SUBJECT: COMANCHE PEAK STEAM ELECTRIC STATION  
DOCKET NOS. 50-445 and 50-446  
CONTAINMENT SUMP PERFORMANCE

TEXAS UTILITIES GENERATING COMPANY  
COMANCHE PEAK STEAM ELECTRIC STATION  
G&H PROJECT NO. 2323  
GIBBS & HILL PAINT REPORT

Per your request, we are attaching the following revised pages regarding the Report on "Evaluation of Paint and Insulation Debris Effects on Containment Emergency Sump Performance" June 1984:

FIGURE-1 OF ADDENDUM TO REPORT ON  
 "EVALUATION OF PAINT AND INSULATION  
 DEBRIS EFFECTS ON CONTAINMENT EMER-  
 GENCY SUMP PERFORMANCE"

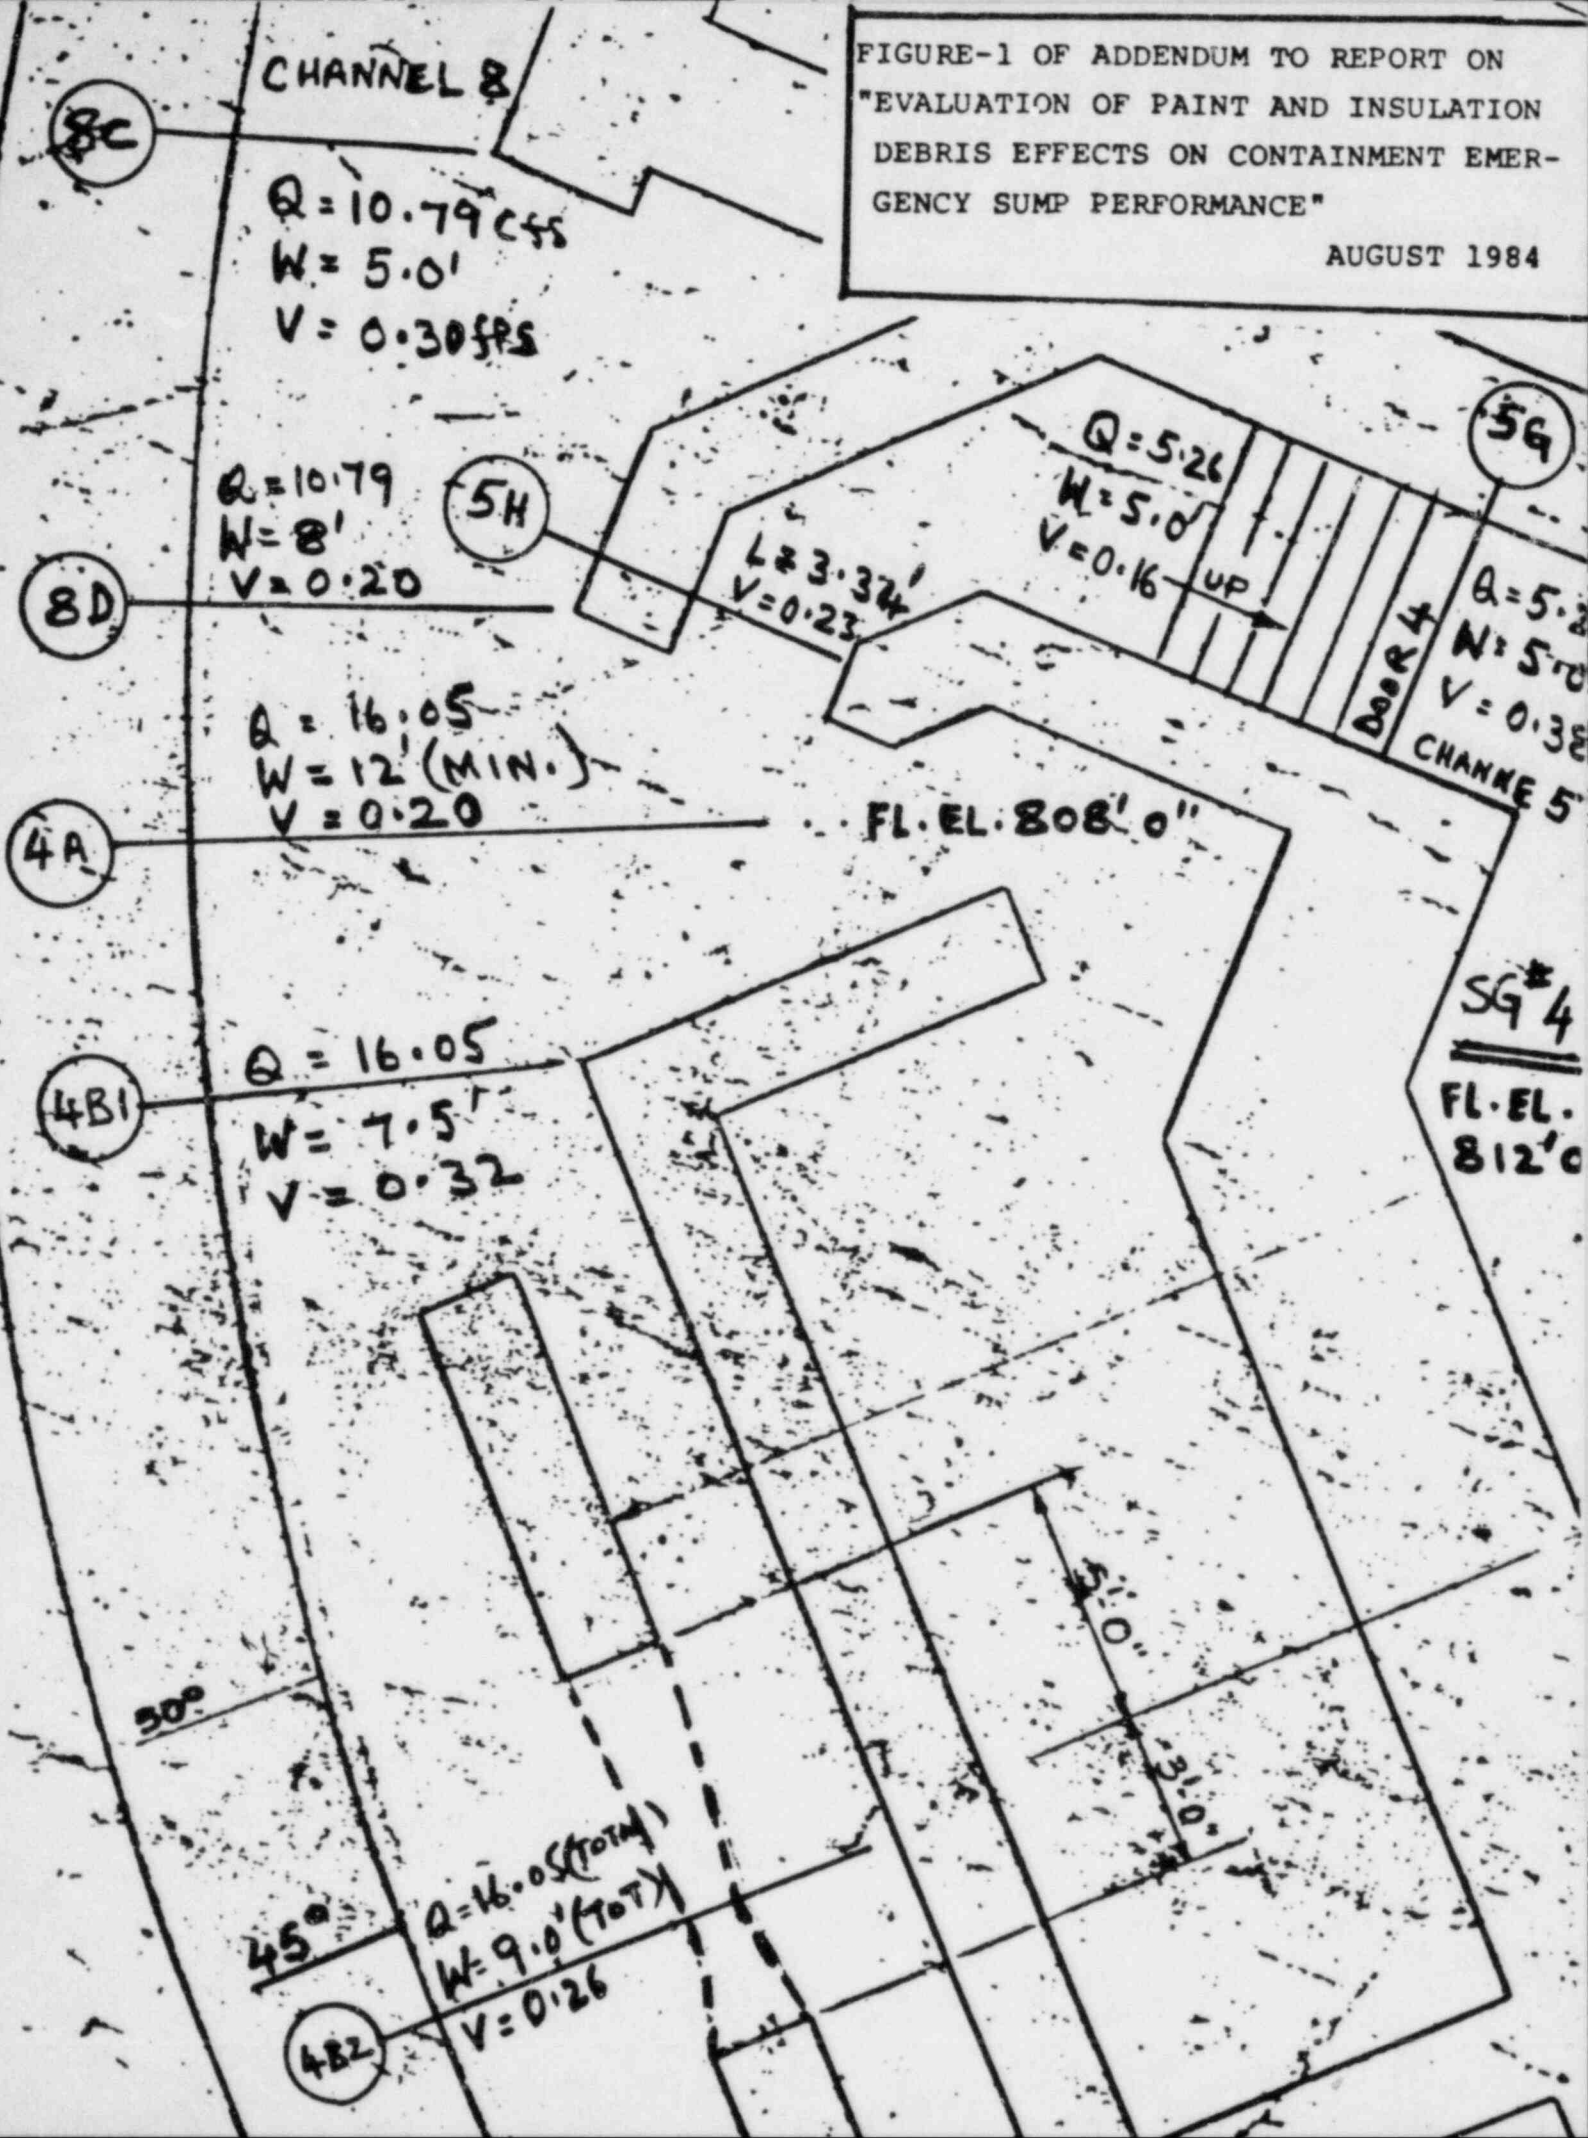
Provide a detailed analysis to verify the velocities presented in Table 5.4-11 using the area surrounding Sub-Channel 4A as a typical case where flow streams from Channels 5 and 8 mix. Evaluate the possibility of flow variations which may result in velocities greater than those presented in the report.

Attached Figure-1 shows the area in question in more detail than shown in the report. Flows at Sub-Channel 4A come from door 4 (Channel 5) and the containment annulus (Channel 8).
